Quality Bulletin

Service Action S10177: Apple CarPlay, Model Year 2021-2023 XC40, C40, XC60, S/V60, V60CC, V90, S90L, V90CC and XC90

GROUP: 39	CAT/NO: S10177	ISSUING DEPARTMENT: Safety and Compliance	CAR MARKET: United States and Canada	
REVISIONS:			ISSUE DATE: 2022-07-14	STATUS DATE: 2022-07-14
Page 1 of 3

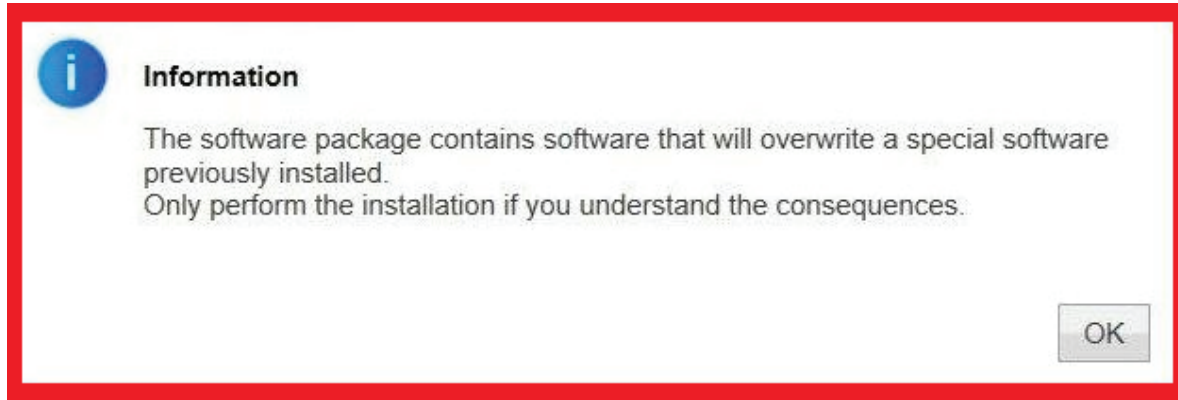
Please note: If the dialogue box below appears in VIDA stating, “The software package contains software that will overwrite a special software previously installed. Only perform the installation if you understand the consequences.” You are to reinstall Software according to TJ 36195 and claim accordingly.
